**AGENDA
FARRAGUT MUNICIPAL PLANNING COMMISSION**

**April 19, 2018
7:00 p.m. Farragut Town Hall**

**SUBJECT: STAFF COMMENTS ON THE REVISED CONCEPT PLAN FOR
THE GRIGSBY PARK, LLC., PARCELS 115.01 AND 116.01, TAX
MAP 130 AND PARCELS 096 AND 096.01, TAX MAP 142**

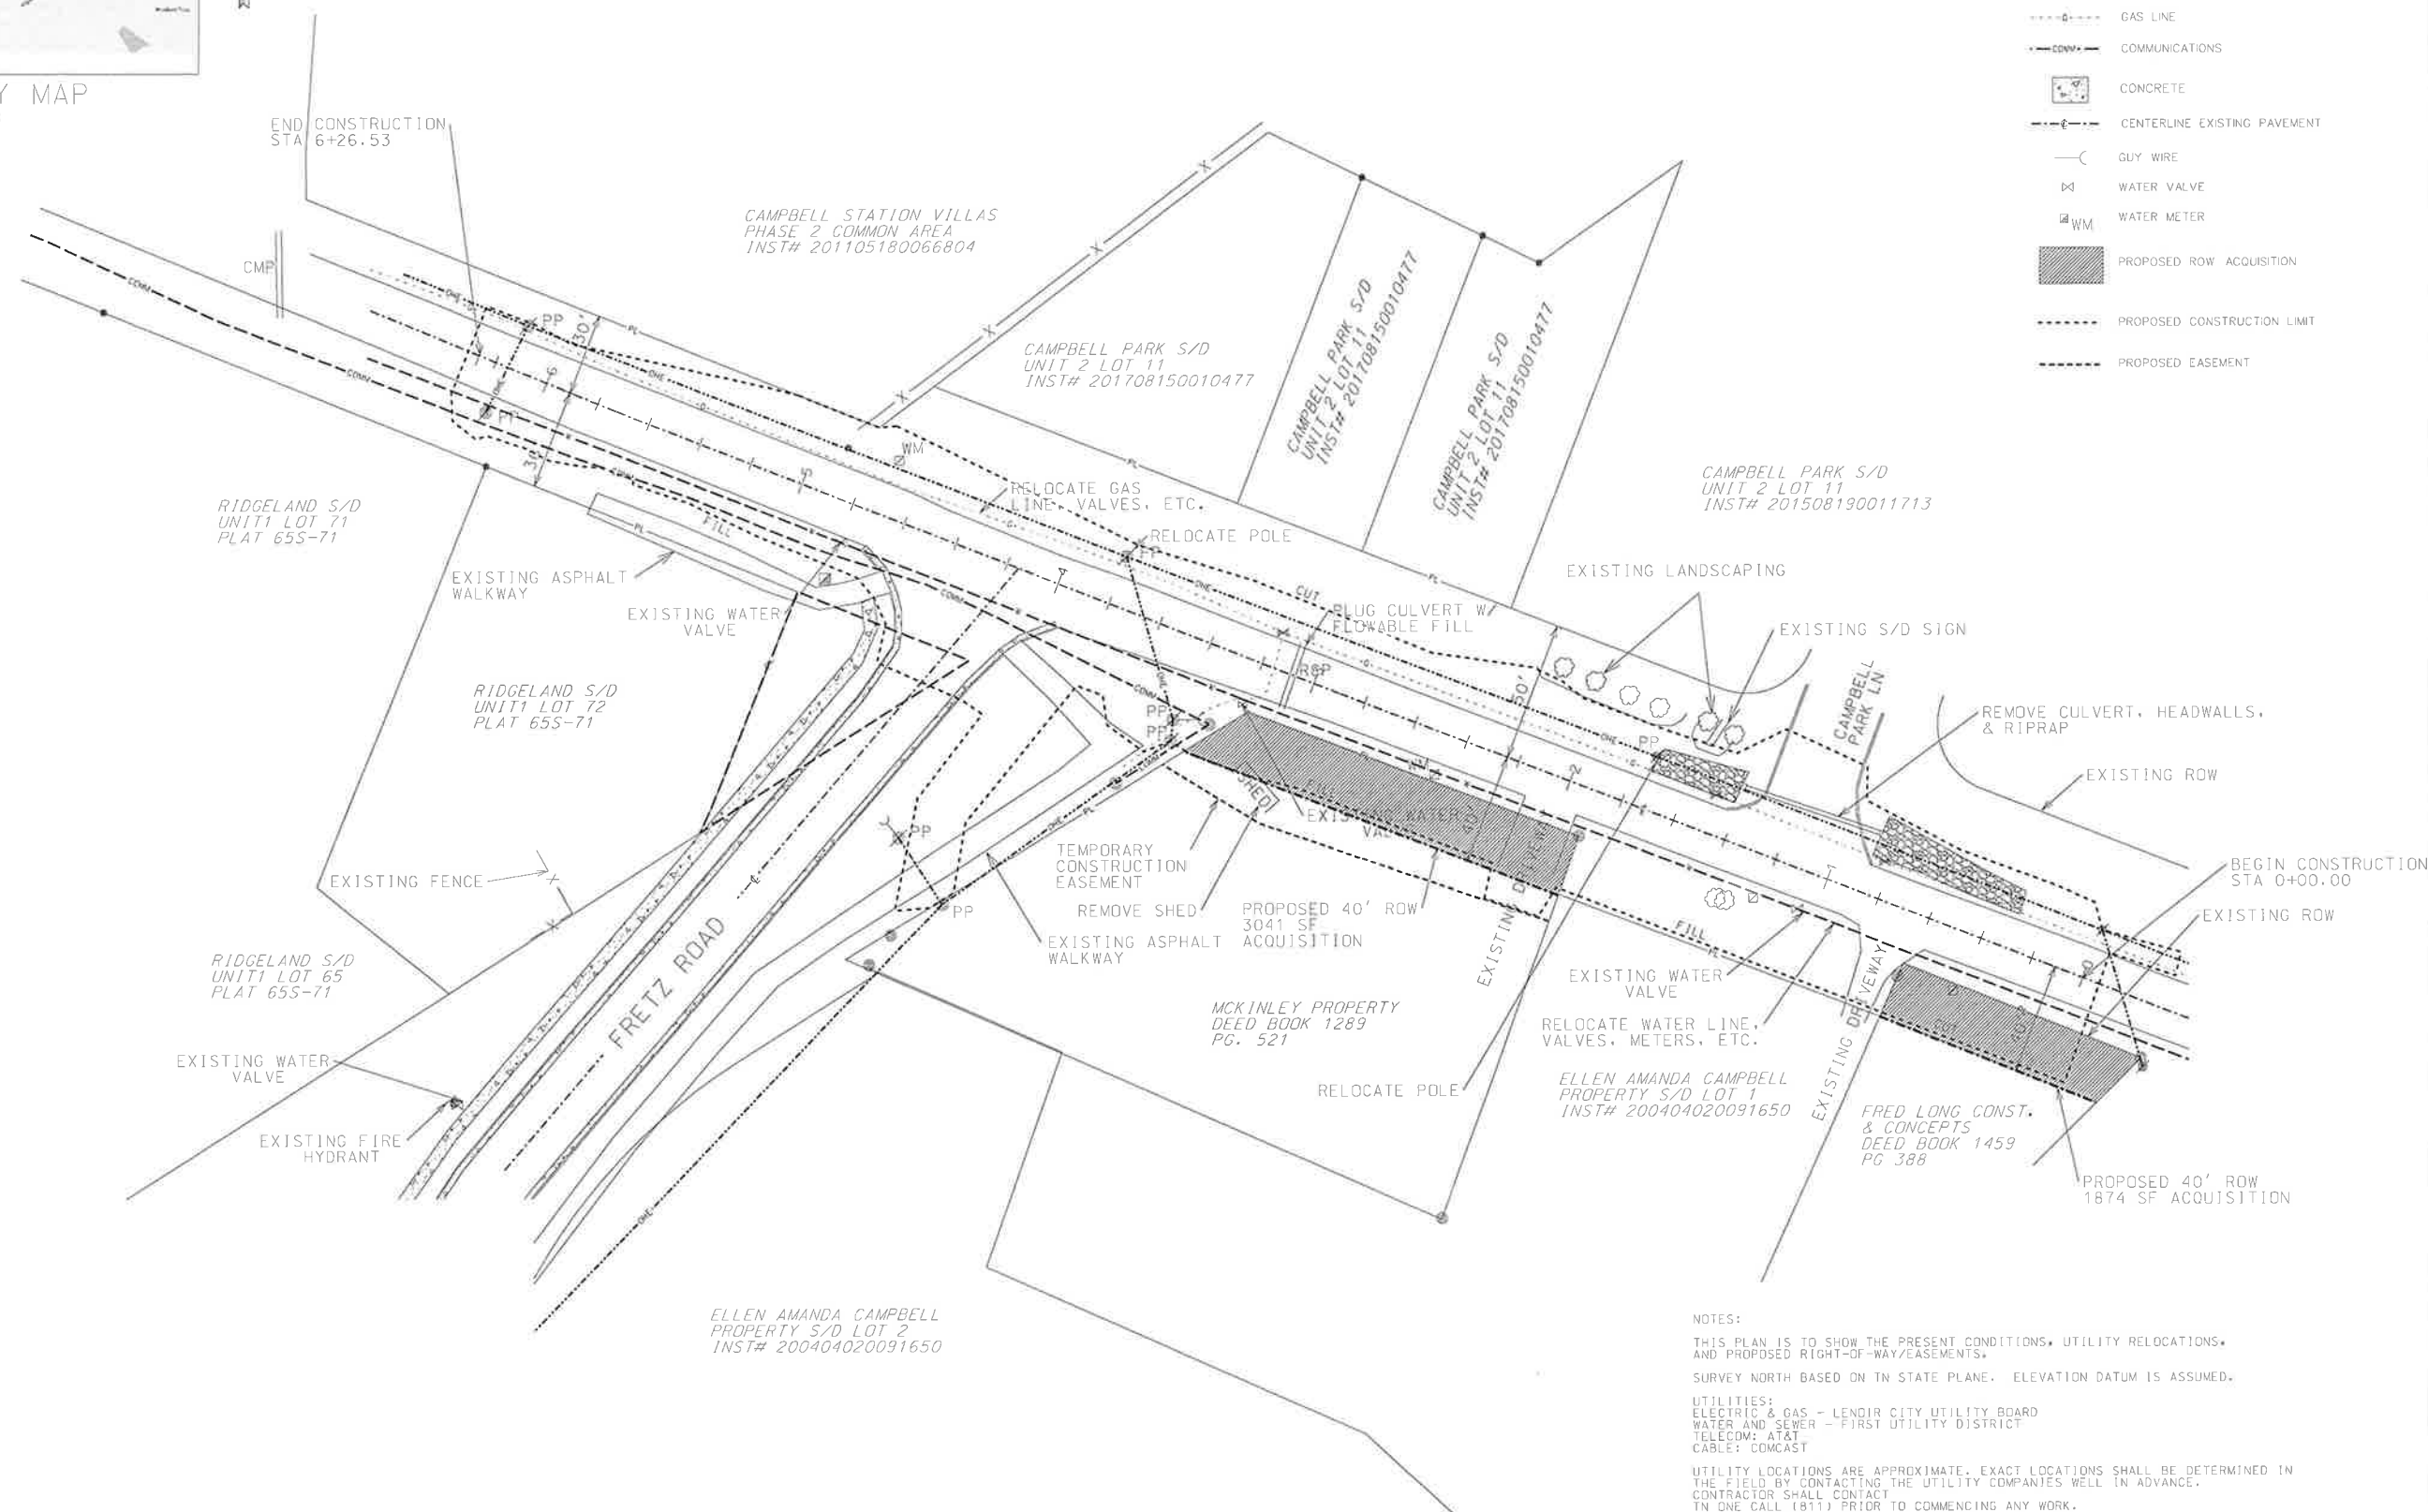
The submitted design is certainly buildable, but plans will need to be further developed before any acquisition of right of way and easements. Construction plans will need to include notes typically found in TDOT-level roadway plans, including General Notes and Pavement Edge Drop-Off Notes. Other elements will need to be considered as well, including reference to the appropriate TDOT standard drawings, quantities tabulation, construction details, etc.

Please include 10' construction easement to allow for working room. Suggest using TDOT line styles and shading to show easements and proposed ROW.

Specify curb inlet as TDOT Type 12 (see Standard Drawing D-CB-12RA)

SHEET
3 OF 7

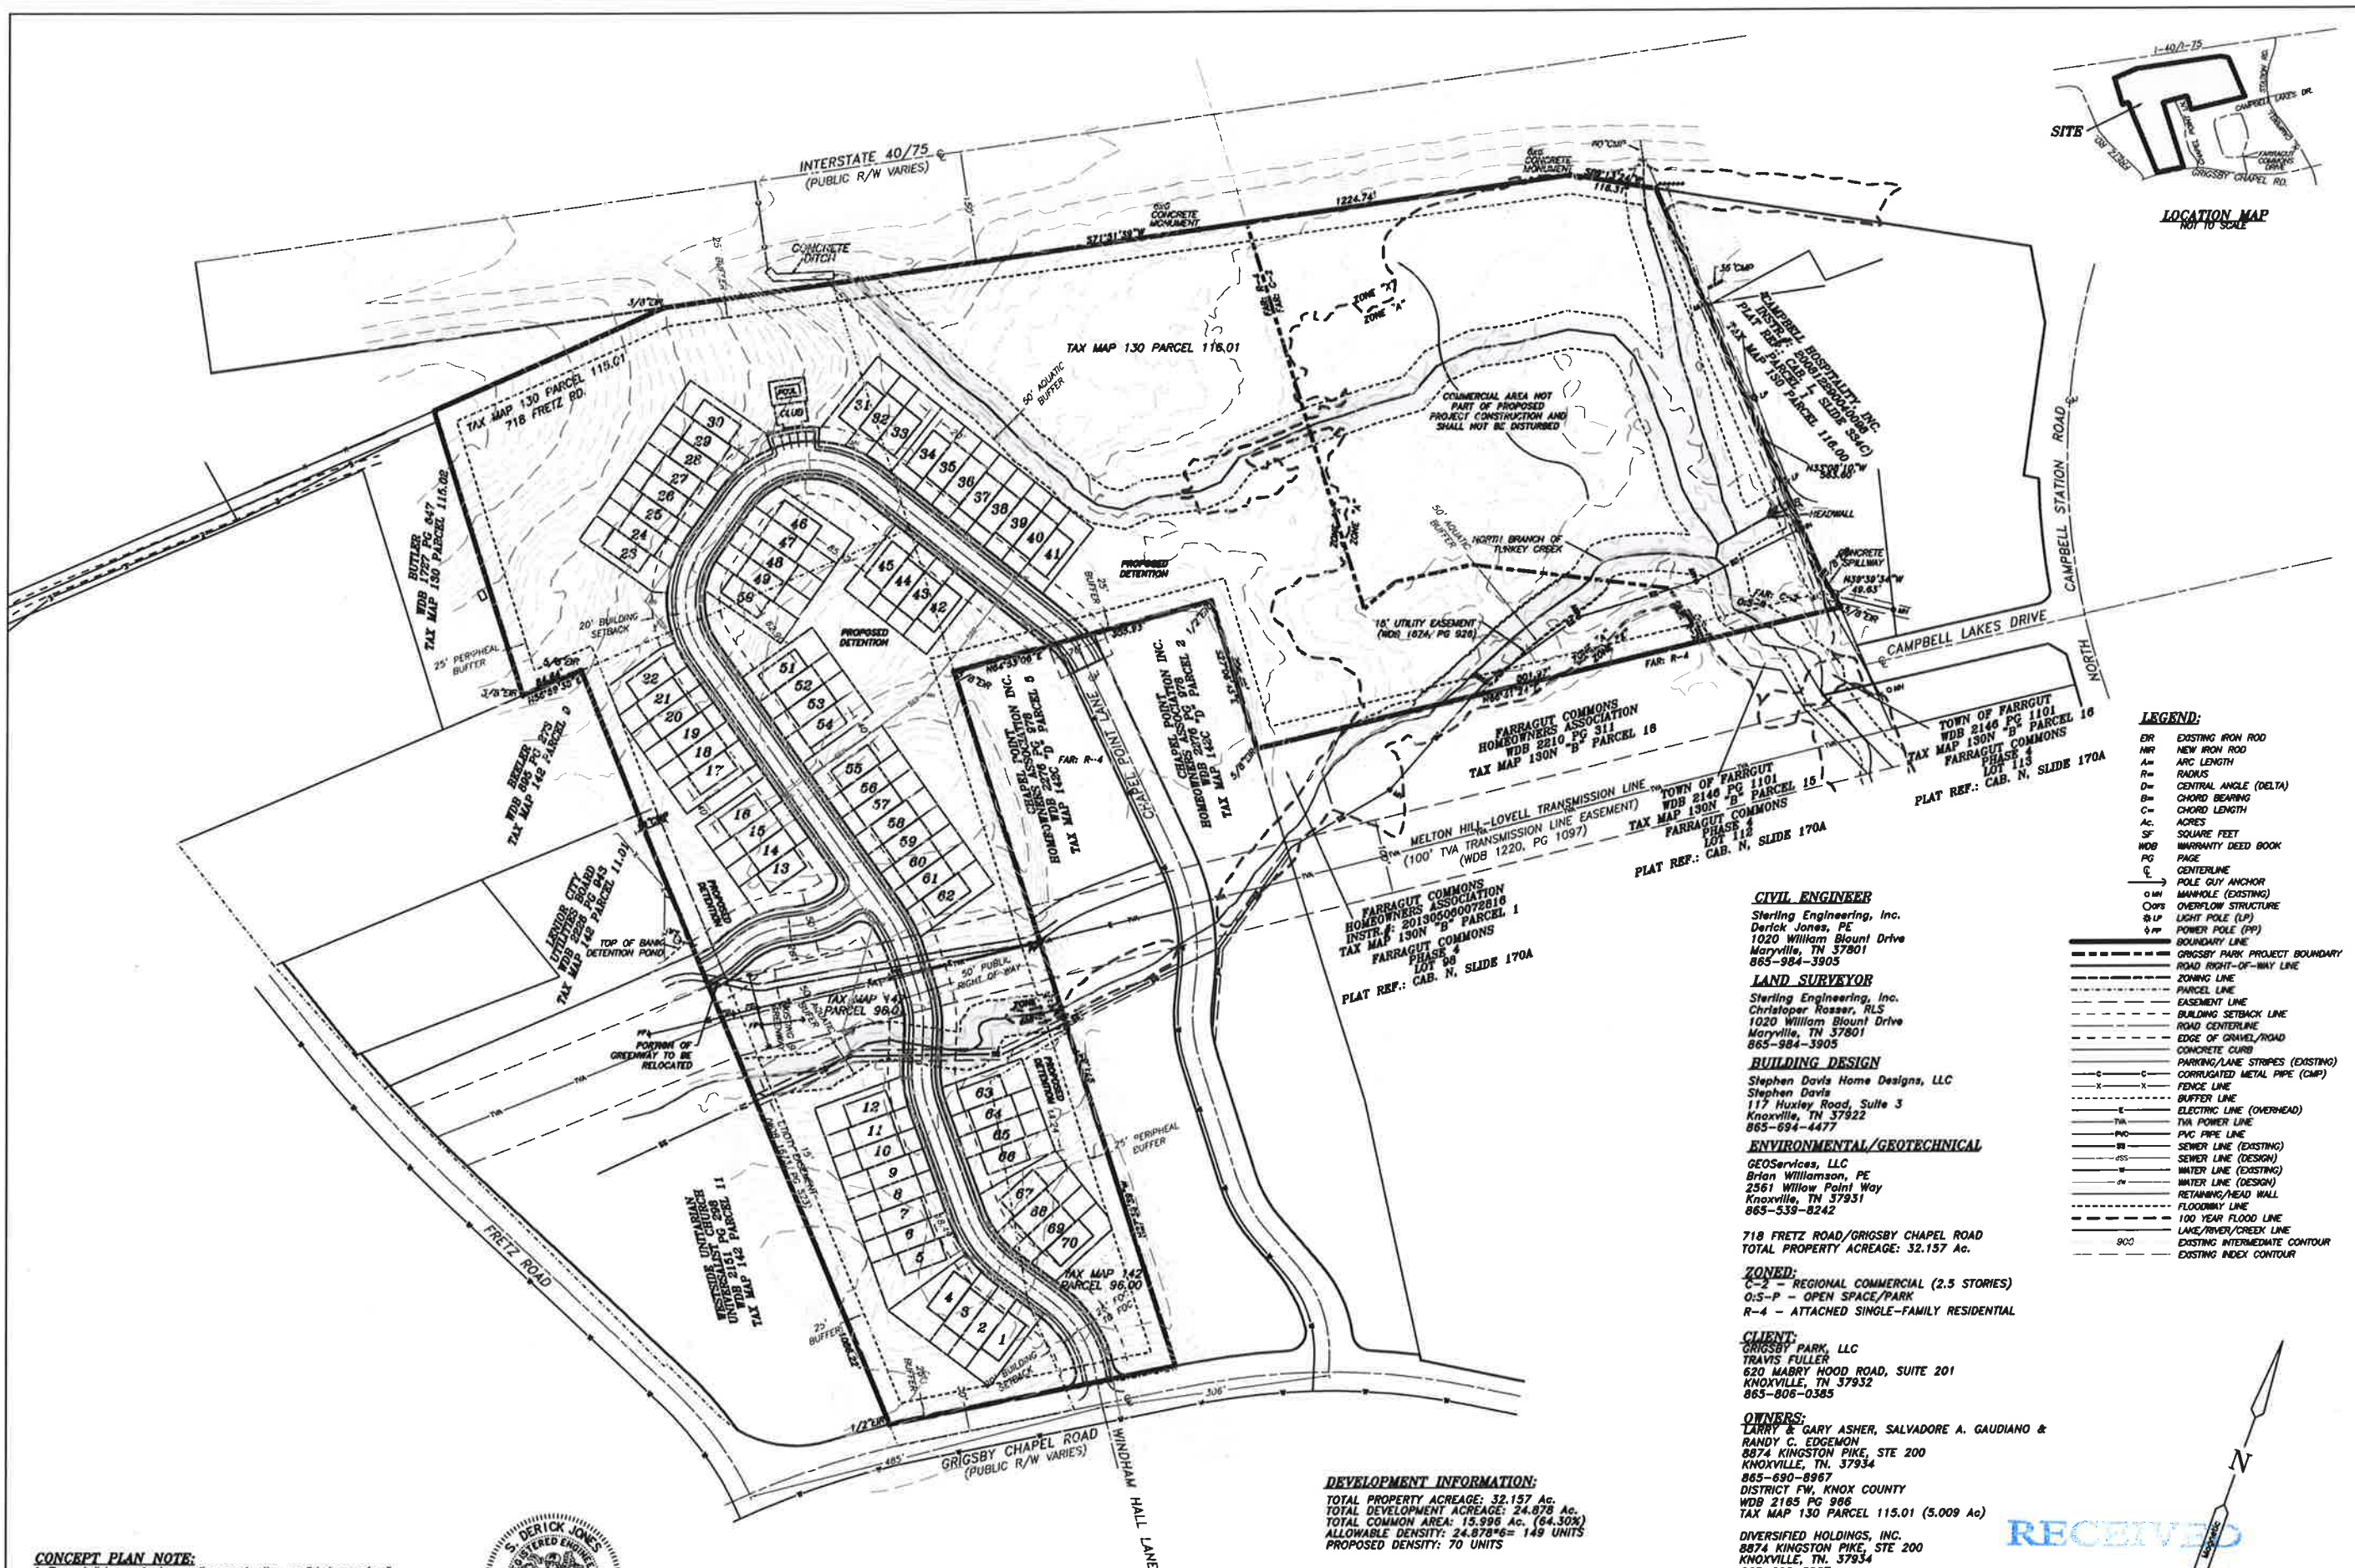
- 10) The physical features sheet needs to identify all significant features including slope areas that exceed 15%, and all surface depressions and sinkholes. The GEOS report lists seven (7) depressions but the plan only clearly identifies one (1). In addition, please address whether there are any identified wetlands on the site;

- 12) Please identify any easement for the existing greenway crossing the site;
- 13) Please verify and ensure that required aquatic buffers encompass springs (and any wetlands) on the site;

- 10) The physical features sheet has been revised as requested.
- 11) Base flood elevations will be established during the design process as required.
- 12) An easement was not found on the existing greenway; however, it will be added to the plat for the property to insure that it is in place.

- 13) Buffers have been revised on Sheet 4 of 6 to reflect additional buffers.
- 14) Per our discussion, a meeting will be held with the Chapel Point POA. If a connection is not approved by them at this time, a temporary turnaround will be provided.
